## 442 NE Maple Leaf Place

Design Review Recommendation

SDCI Project # 3024493

e-w section at rooftop amenity ^

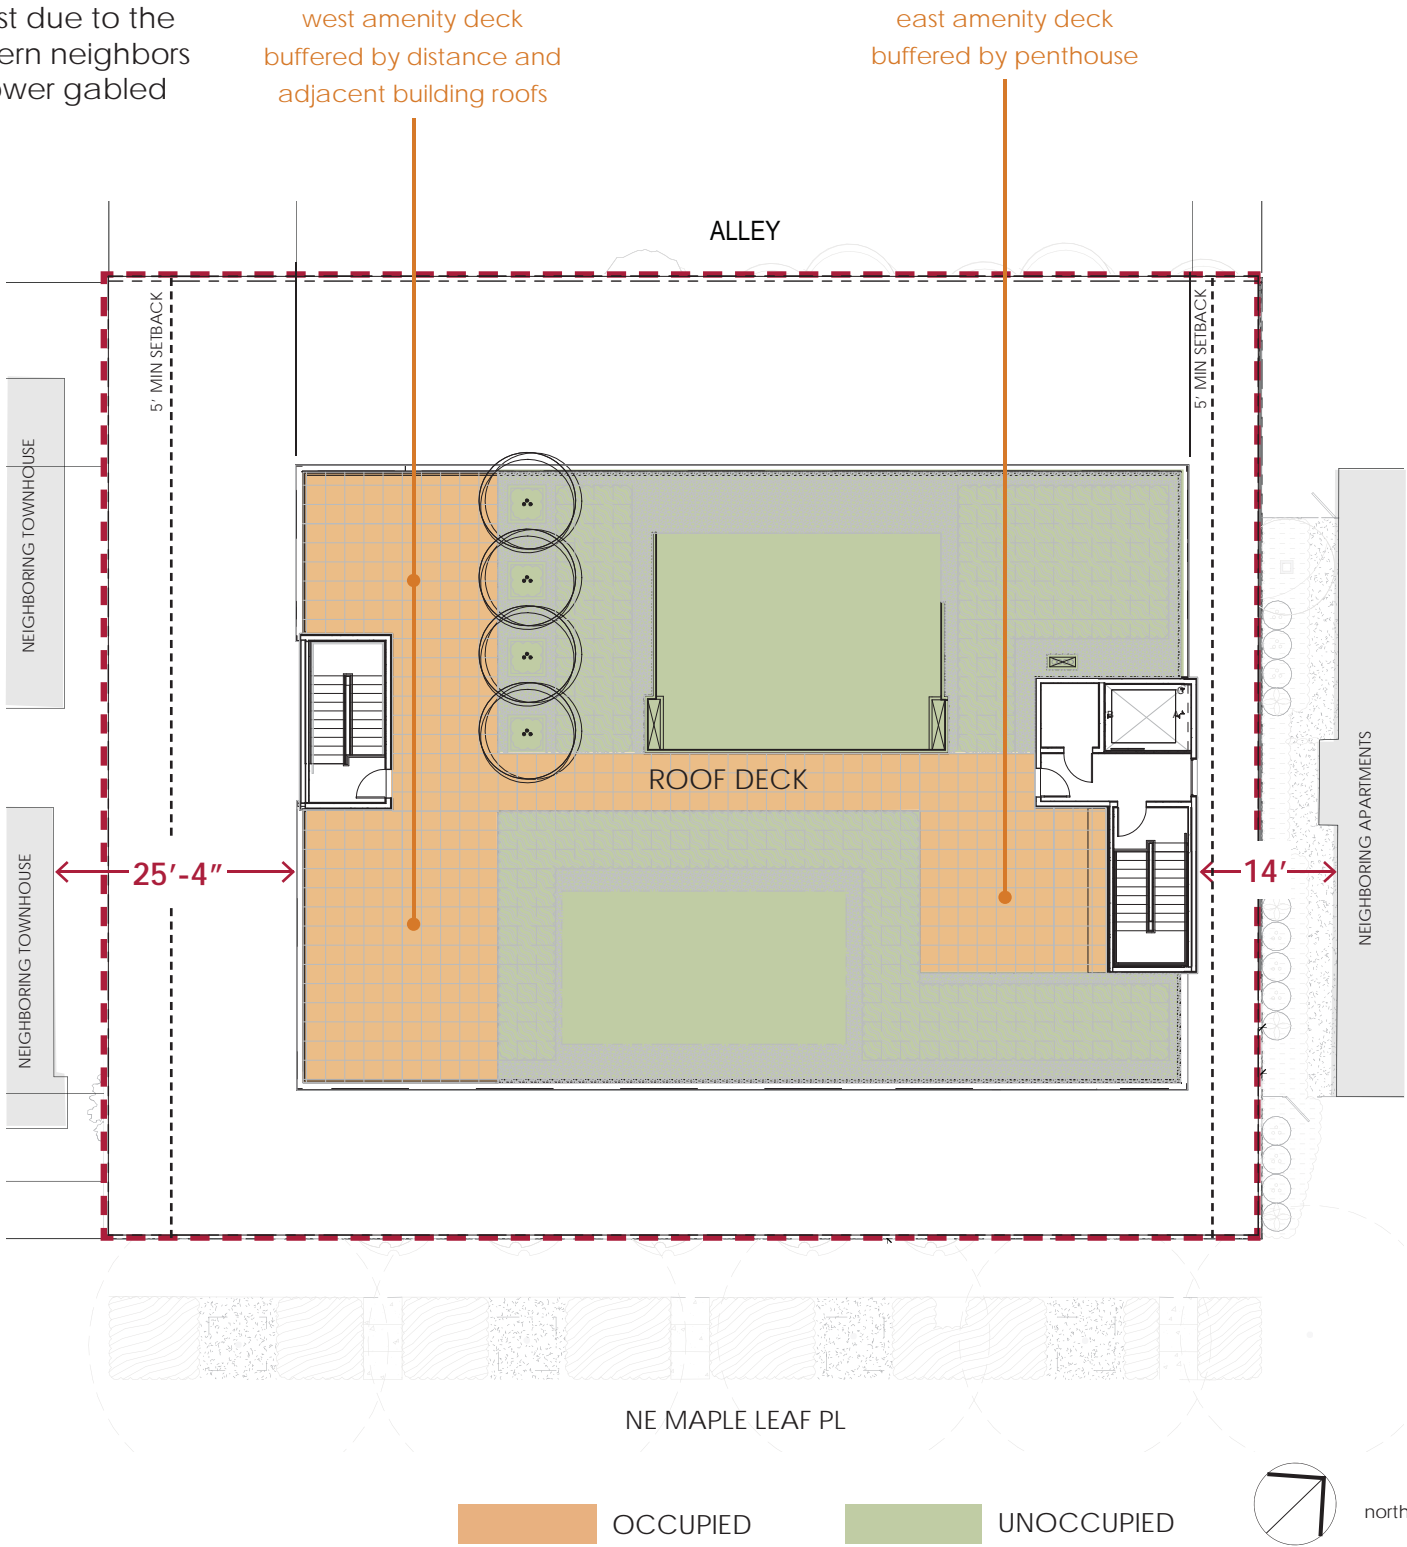
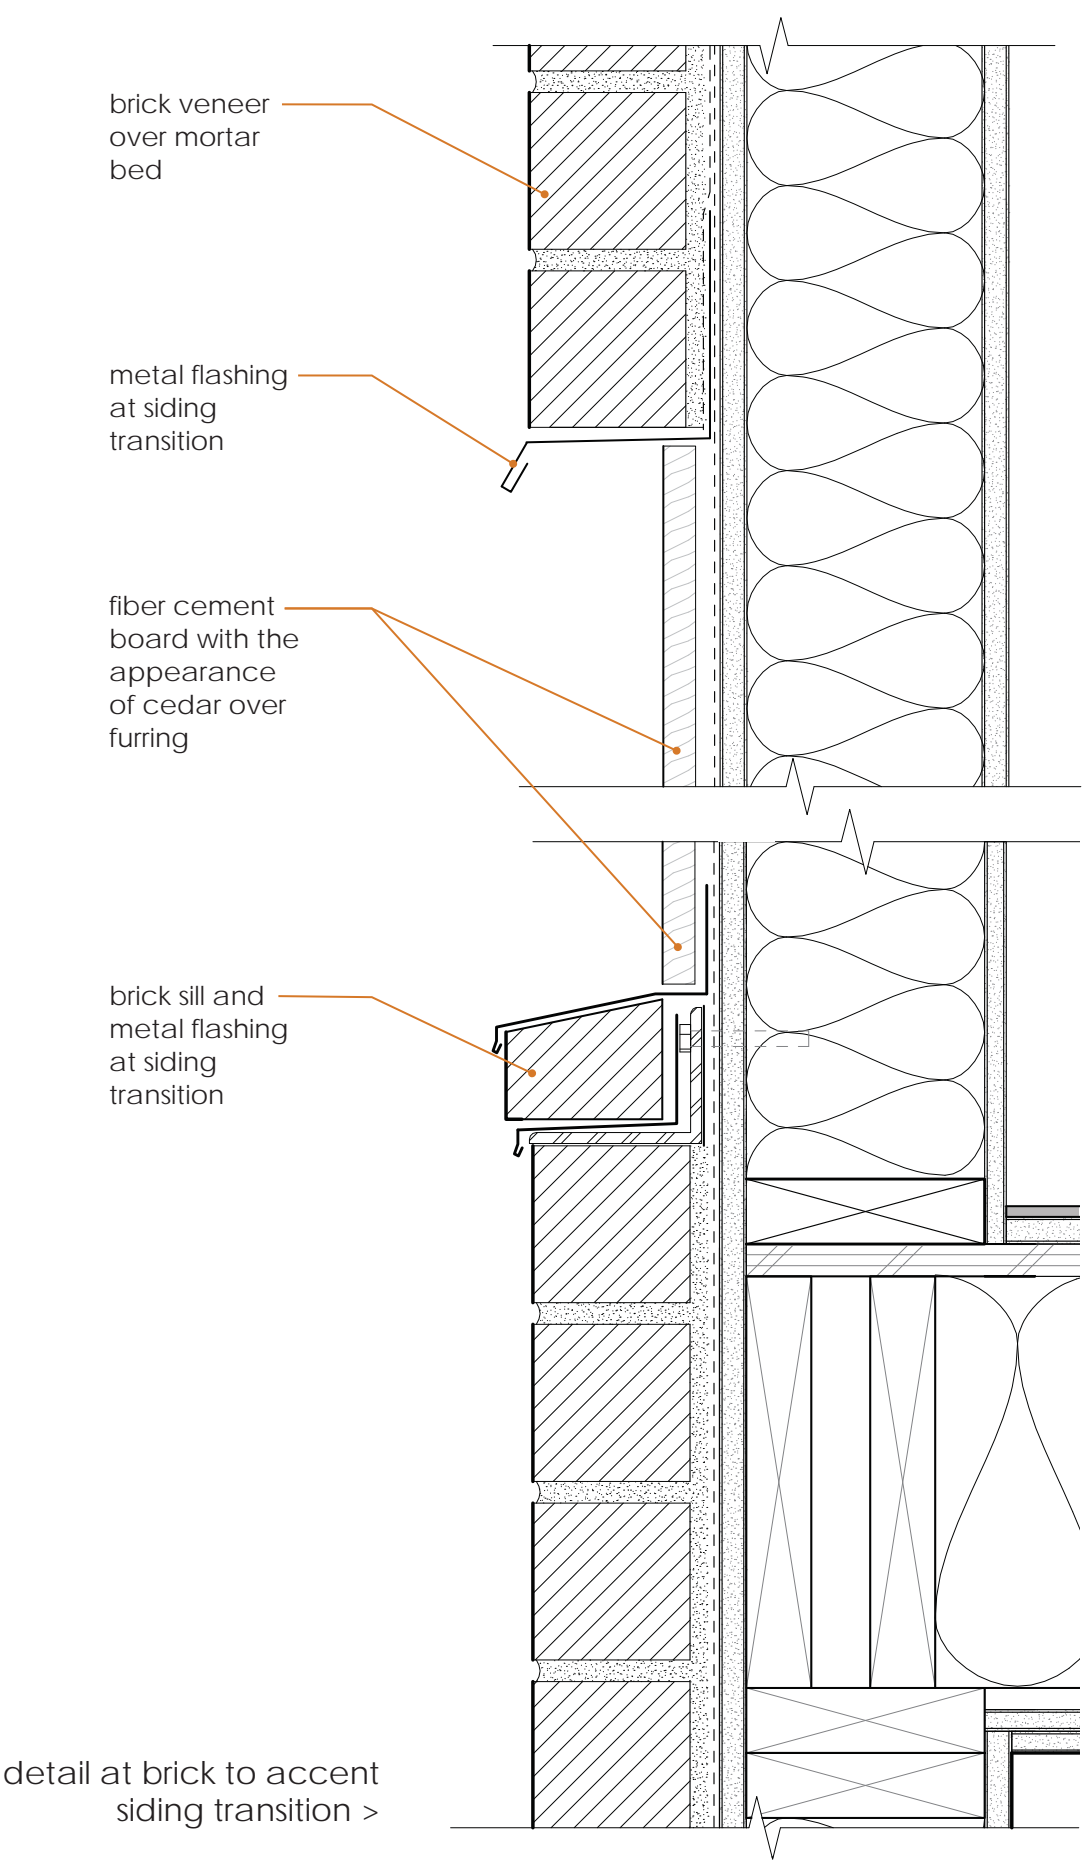
direction: *the Board requested demonstration of “how the rooftop` amenity space design has been configured to ensure that there are no view impacts to the adjacent buildings”*

**response:** To protect the privacy of the eastern multifamily residential neighbor, the occupied rooftop amenity spaces do not have any visibility towards the east due to the position of the intervening stair/elevator penthouse. Views toward the western neighbors are buffered by distance (more than 25’ separates the buildings) and the lower gabled roof form of the townhouse neighbor.
